Steven M. Clouse WRC Digester Mixing and System Enhancements Phase 3 Rebid
Solicitation Number: CO-00581
Job No.: 20-6501

ADDENDUM 2
November 2, 2022

**STEVEN M. CLOUSE WRC
DIGESTER MIXING AND SYSTEM
ENHANCEMENTS
PHASE 3**

1 DIGESTER No.5 LOWER PLAN
 01S08 SCALE: 1/8"=1'-0"

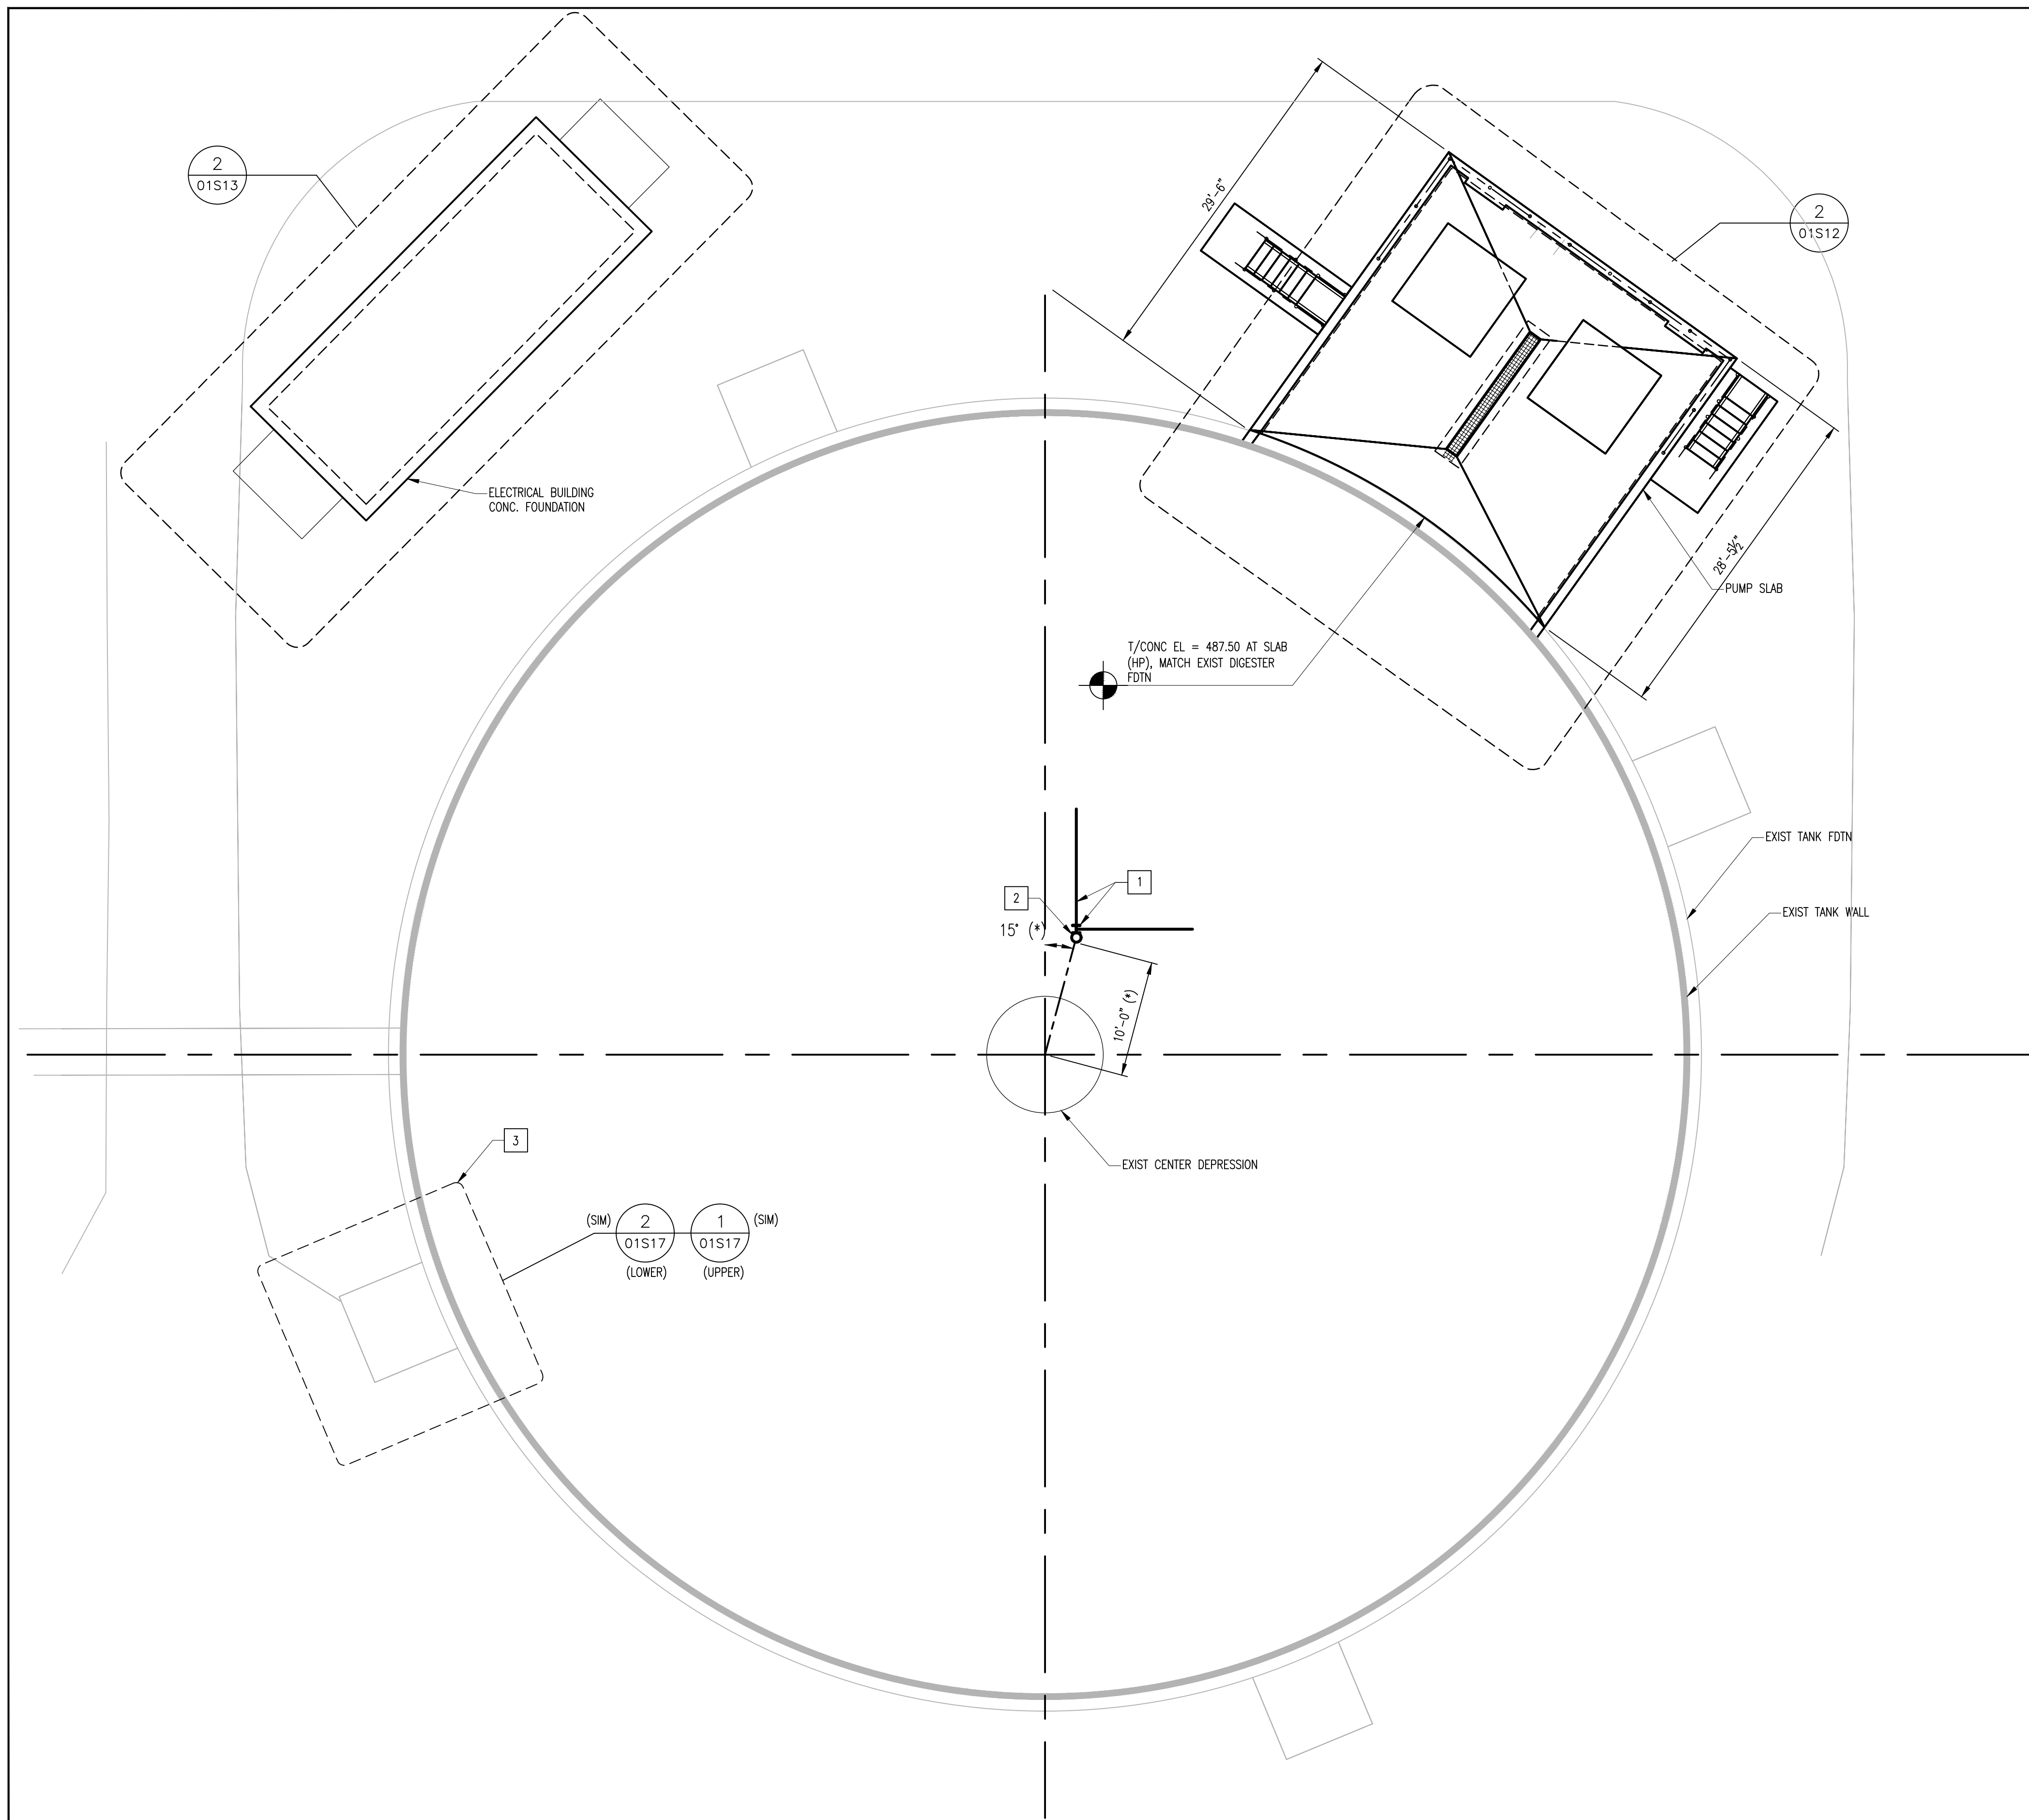
- On dwg 01S08 the Scale suggested of 1/8" = 1'-0" is not matching the graphic scales or the dimensions given in the details. Please advise.
Response: Please see the Changes to the Plans section of this Addendum.

1. Drawing 01E10, Detail E38: Change detail title to read, "ROADWAY ELECTRICAL MANHOLE."
2. Delete Drawings 01S01 through 01S17 in their entirety, and replace with revised Drawings 01S01 to 01S17 included in this addendum.
